**AGENDA FOR REGULAR MEETING  
VILLAGE OF TINLEY PARK  
PLAN COMMISSION**

**THE RESERVE AT TINLEY PARK – NORTHEAST CORNER OF OAK PARK AVENUE AND 183<sup>RD</sup> STREET – SITE PLAN APPROVAL (New Item)**

# PLAN COMMISSION STAFF REPORT

Site Plan Approval

**LANDSCAPING**

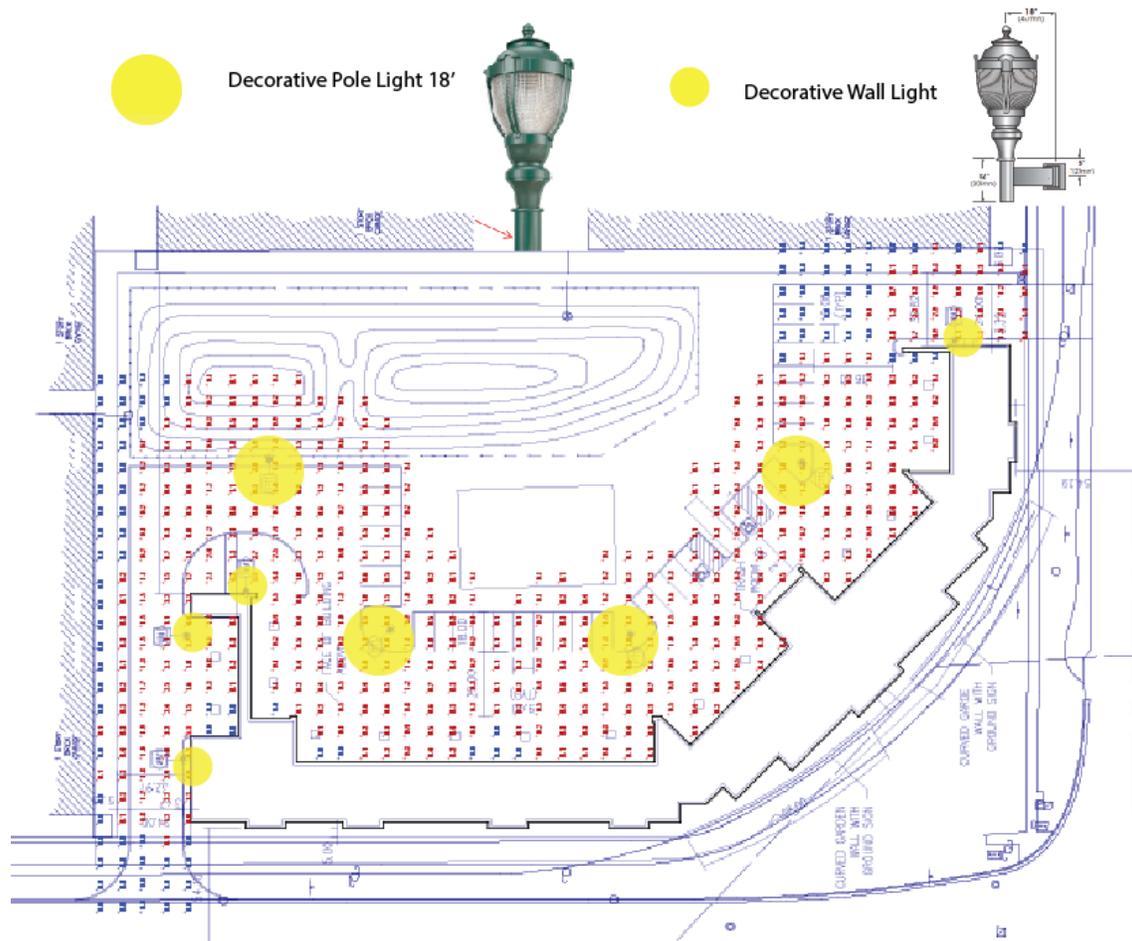
bufferyard width of 5' with 2 shade trees, 1 ornamental tree and 20 shrubs per 50 linear feet. The proposed plan meets the bufferyard requirements as outlined in the table below.

In addition to the bufferyard, the parking lot must meet the 15% interior landscaping requirement for parking lots. The proposed plan provides 15.2% of the parking area as landscaping. Street trees are also required at a rate of 1 tree per 25' linear feet of frontage. Due to the overhead lines along both street frontages, staff recommends the use of ornamental trees rather than shade trees. Twenty-three ornamental trees are provided along the street frontages. The applicant also provided landscaping in the large triangular area in the parkway adjacent to the intersection per staff recommendation. Shade trees have been provided adjacent to the tot lot and the parking areas at the rear of the property. Appropriate seed mix has been provided in the storm water detention area consistent with IDOT seeding recommendations. Per the Legacy Code interior lot landscaping for multi-family units are required to provide 1 tree per dwelling unit. While the proposed plan provides some additional trees, the plan still does not meet code. Staff is working with the Applicant to bring the plan into compliance.

**Open Item #2: Landscape Plan does not meet Village requirements.**

SHEET NUMBER  
AS1

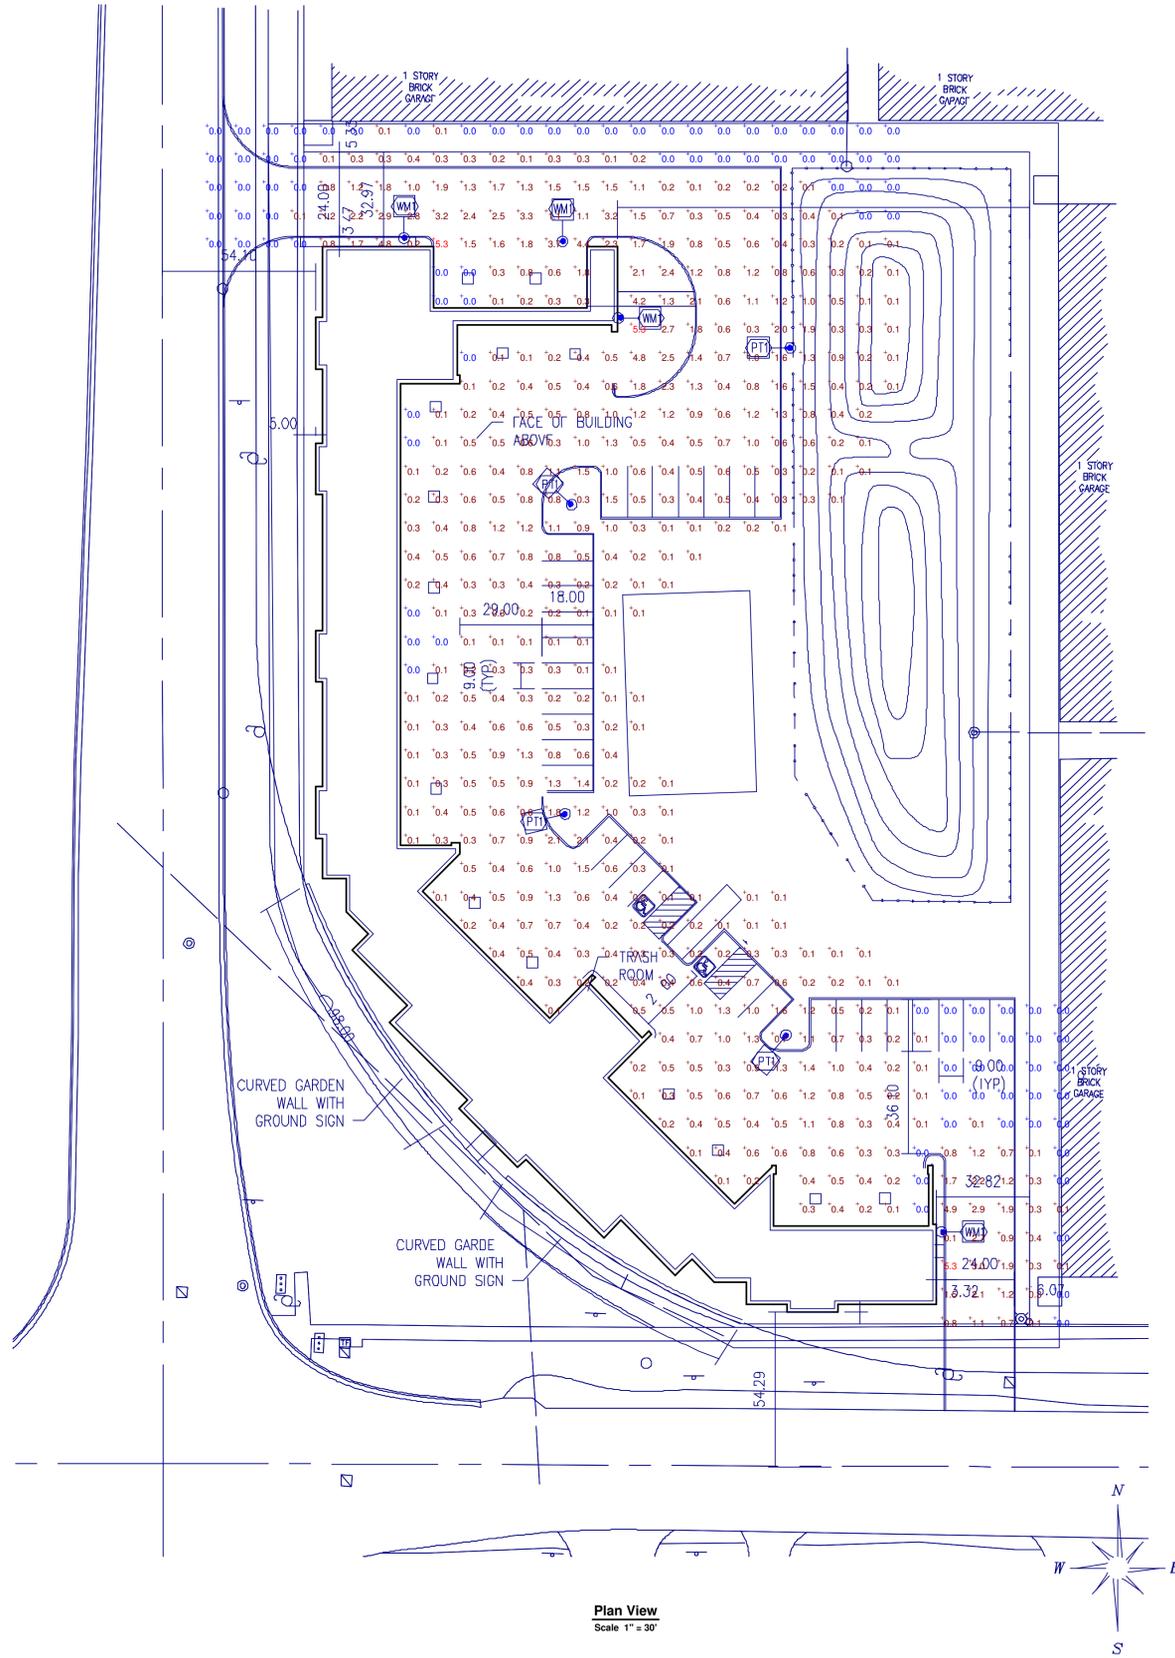
Vehicle access is provided at the north end of the project at Oak Park Avenue and at the east property line on 183<sup>rd</sup> Street. Landscaping will be provided to buffer the edges of the parcel with the adjacent residential uses. A 10' bike trail and sidewalks provide pedestrian and bicycle access per the intent of the Legacy Code.

OPEN ITEM	SUGGESTED RESOLUTION
1. Retention of 5' public sidewalks.	Staff recommends the Plan Commission allow the existing 5' wide sidewalks to remain.
2. Landscape Plan is incomplete.	Submit final Landscape Plan.
3. Lack of definition for rear entrance.	Staff recommends adding a metal canopy over the rear entrance to provide additional way finding and aesthetic interest.
4. Engineering review is incomplete.	Provide engineering comments to Applicant.
5. The property must comply with the Village's Crime Free Housing Program prior to signing leases with renters.	The Applicant should contact the Crime Free Housing Program Coordinator prior to begin the process.

GEOMETRY PLAN		DRAWN BY: APK	CHECKED BY: CML
		SCALE: 1" = 20'	DATE: 10/27/2015
		JOB NUMBER: 15-140	SHEET: C 6.0
#	DATE	DESCRIPTION	
1	12-11-2015	PER VILLAGE	
2	01-11-2016	PER VILLAGE AND IDOT	
3			
4			
5			
6			
7			
8

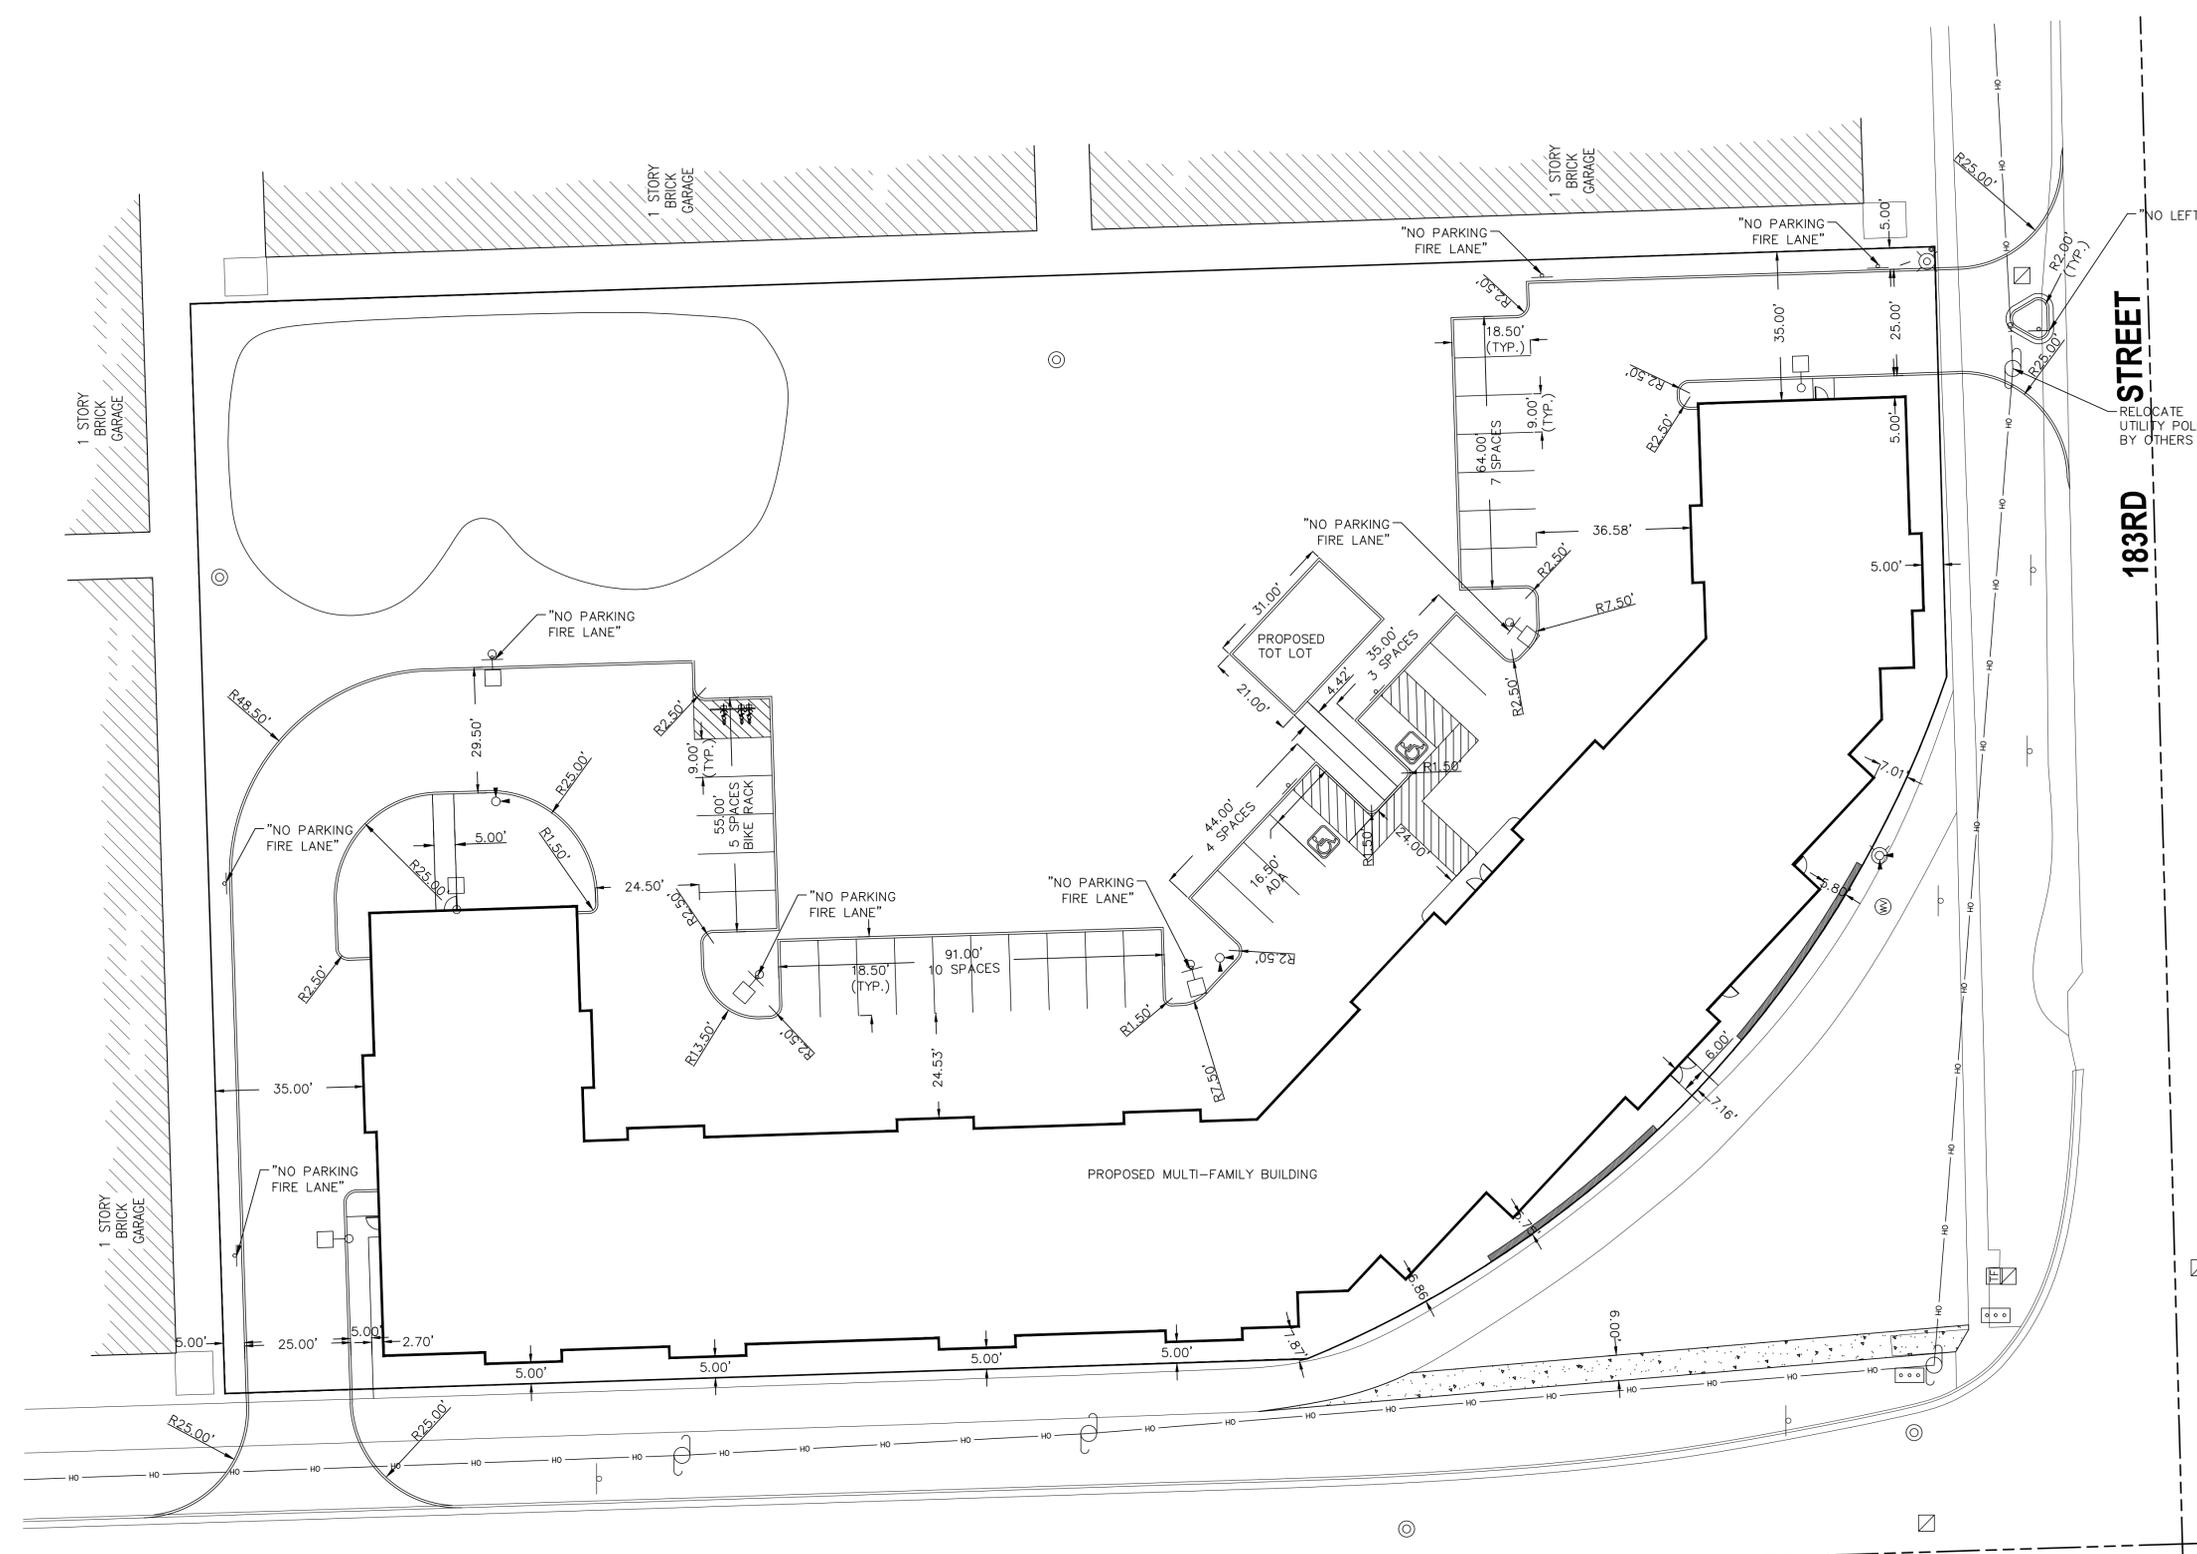
- △ REVISED PLANS PER VILLAGE OF TINLEY PARK DATED 01-11-16.
- 1. REVISED BUILDING DIMENSIONS
- △ REVISED PLANS PER VILLAGE OF TINLEY PARK DATED 12-11-15.
- 1. SETBACK DIMENSIONS AND POND LOCATION
